Water Department

City of Attleboro ADA Transition Plan

June 2021

West Street Water Treatment Facility
Year Built: 1995

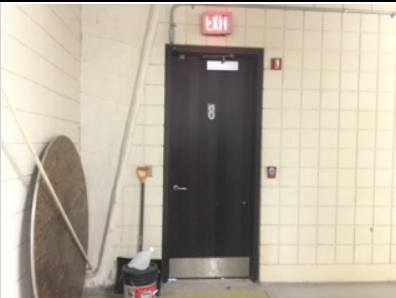
- Recommend providing a guardrail alongside path from Exit 2 alongside the water at the water treatment facility.

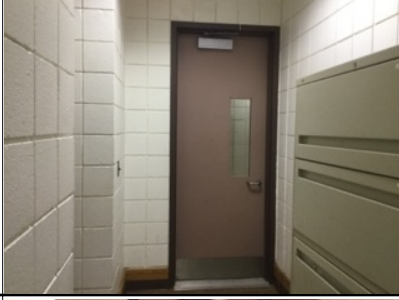
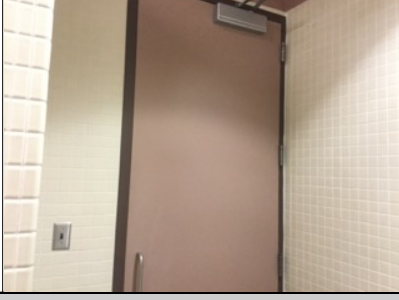
ID	Location	Floor	Room	Element	Type	Photo	Issues	Current Measure	Recommendations	Quantity	Price	Cost Estimation
Approach and Entrance												
Curb Ramp												
1	Main Entrance	Ext.		Curb Ramp	N/A		Surface not stable, firm and slip-resistant	-	Repair surface.	1	144	\$144
Off-Street Parking Lot or Garage												
2	Main Entrance	Ext.		Off-Street Parking Lot or Garage	Visitor		Total # of designated van accessible spaces	-	Enlarge one accessible parking space to be a van accessible parking space. Add the designation "Van Accessible" to the sign located at the van accessible space.	1	800	\$800
Emergency Exit												
3	Main Entrance (Egress)	1		Emergency Exit	N/A		Tactile sign not provided at exit	- -	Provide tactile exit signs with raised characters and braille at exit doors. Mount signs between 48"- 60" above the finished floor located on the latch side of the door. Where a tactile sign is provided at double doors with two active leafs, the sign shall be located to the right of the right hand door.	1	232	\$232

4	Main Entrance (Egress)	1		Emergency Exit	N/A		Tactile sign not provided at exit	-	Provide tactile exit signs with raised characters and braille at exit doors. Mount signs between 48"- 60" above the finished floor located on the latch side of the door. Where a tactile sign is provided at double doors with two active leafs, the sign shall be located to the right of the right hand door.	1	232	\$232

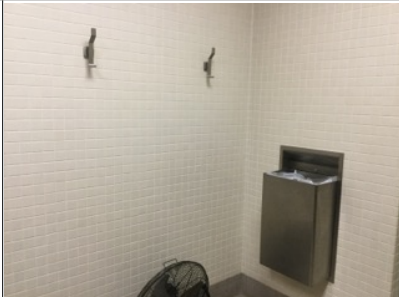
ID	Location	Floor	Room	Element	Type	Photo	Issues	Current Measure	Recommendations	Quantity	Price	Cost Estimation
5	Exit 2	1		Emergency Exit	N/A		Tactile sign not provided at exit		Provide tactile exit signs with raised characters and braille at exit doors. Mount signs between 48"- 60" above the finished floor located on the latch side of the door.	1	232	\$232
6	Exit 2	1		Emergency Exit	N/A		Illuminated Int. Symbol of Acc. not provided (MAAB)	-	When illuminated signage is replaced at this exit, provide new illuminated signage with the International Symbol of Accessibility.	1	-	\$0
7	Exit 2	1		Emergency Exit	N/A		Illuminated Int. Symbol of Acc. not provided (MAAB)	-	When illuminated signage is replaced at this exit, provide new illuminated signage with the International Symbol of Accessibility.	1	-	\$0
8	Exit 2	Ext.		Emergency Exit	N/A		Threshold > 1/2" high	1"	Alter the threshold to be 1/2" high max.	1	150	\$150

Access to Goods and Services												
Interior Access Route												
9	Corridor to Main Entrance	1		Interior Access Route	N/A		Route < 36" wide	35.5"	Ensure that a clear width of 36" min. is maintained at the accessible route. Relocate shelf.	1	Labor	\$0

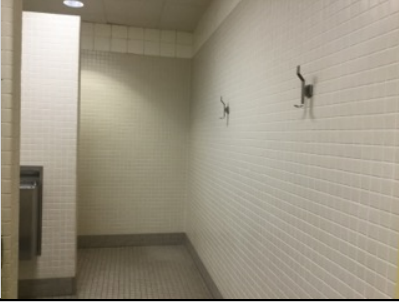
ID	Location	Floor	Room	Element	Type	Photo	Issues	Current Measure	Recommendations	Quantity	Price	Cost Estimation
Doors, Doorways, & Gates												
10	Main Entrance	1		Doors, Doorways, & Gates	Vestibule		Door requires > 5 lbs. of force to open	10 lbs.	Adjust closers so doors do not require more than 5 pounds of force to open.	1	Labor	\$0
11	Women's Toilet Room	1		Doors, Doorways, & Gates	Toilet Room		Door requires > 5 lbs. of force to open	11 lbs.	Adjust closers so doors do not require more than 5 pounds of force to open.	1	Labor	\$0
12	Route to Secondary Exit	1		Doors, Doorways, & Gates	Assembly Space		Door requires > 5 lbs. of force to open	10 lbs.	Adjust closers so doors do not require more than 5 pounds of force to open.	1	Labor	\$0
13	Men's Toilet Room	1	E	Doors, Doorways, & Gates	Toilet Room		Door requires > 5 lbs. of force to open	15 lbs.	Adjust closers so doors do not require more than 5 pounds of force to open.	1	Labor	\$0

Signage												
14	Conference Room	1		Signage	Designation		<p>Raised characters not provided on sign</p> <p>Raised characters < 48" or > 60" above ground</p> <p>Braille not provided on sign</p> <p>Sign not located on the latch side of the door</p>	- 36.5" - -	<p>Provide text with raised characters duplicated in braille on sign. Mount signs so that the baseline of the lowest tactile character is 48" min. above finished floor and the baseline of the highest tactile character is 60" max. above the finished floor.</p> <p>Locate sign at permanent rooms alongside the door on the latch side.</p>	1	232	\$232

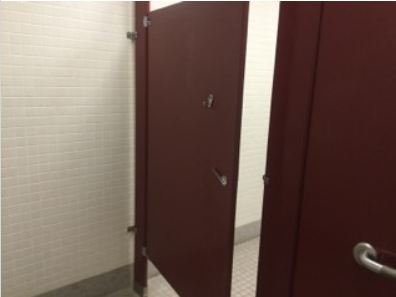
ID	Location	Floor	Room	Element	Type	Photo	Issues	Current Measure	Recommendations	Quantity	Price	Cost Estimation
15	Main Entrance - Reception	1		Signage	Designation		Visual characters < 40" above ground	34.5"	Mount visual sign so that the baseline of the lowest character is 40" min. above the finished floor.	1	Labor	\$0
16	Main Entrance	1		Signage	Informational		Visual characters < 40" above ground	34.5"	Mount visual sign so that the baseline of the lowest character is 40" min. above the finished floor.	1	Labor	\$0
17	Men's and Women's Toilet Rooms	1		Signage	Designation		Sign not located on the latch side of the door	-	Locate sign at permanent rooms alongside the door on the latch side.	2	Labor	\$0
Service Counter												
18	Main Entrance - Reception	1		Service Counter	N/A		Counter > 36" high	41.75"	Provide a counter that is 36" max. above the ground or finished floor.	1	880	\$880
Operable Parts

19	Men's Toilet Room	1		Operable Parts	Clothes Rod/Hooks		Reach < 15" or > 48"(forward/side approach)	63.5"	Lower at least one coat hook so that it is no higher than 48".	1	150	\$150
